Replacement Parking Brake Pads

Product: Groundsmaster® 7200

Subject: Replacement parking brake pads and adjustable linkage now available

Figure 1

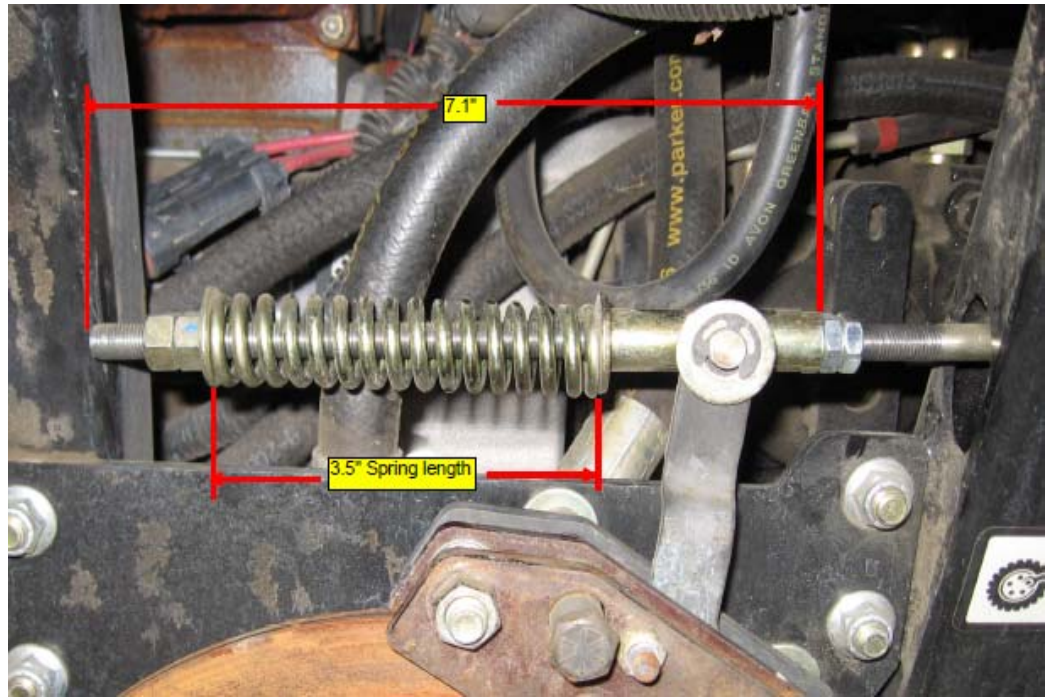
Parking brake pads are subject to wear and require periodic replacement. Previously, brake pads for the GM7200 models were only available as part of the caliper assembly. Toro is now offering replacement brake pads separately from the caliper. The new pads incorporate a harder friction material to support increased service life. In addition, the parking brake linkage system has been redesigned for 2011 to provide adjustment to account for pad wear. The adjustable brake linkage can be retrofitted to older traction units.

If parking brake pads require replacement, install the Replacement Brake Pad Service Kit (120-0015). See Figure 1 for base adjustment. The distance of 7.1" (18.03 cm) is the expected distance when new brake pads are installed. This distance will increase as the parking brake pads wear. The important dimensions are the spring length settings. Spring length should be set to 3.5" (8.89 cm) when the parking brake is off. When the parking brake is set correctly and the brake is applied, the spring will be compressed to a 3.0" (7.62 cm) length (0.5" (1.27 cm) of compression).
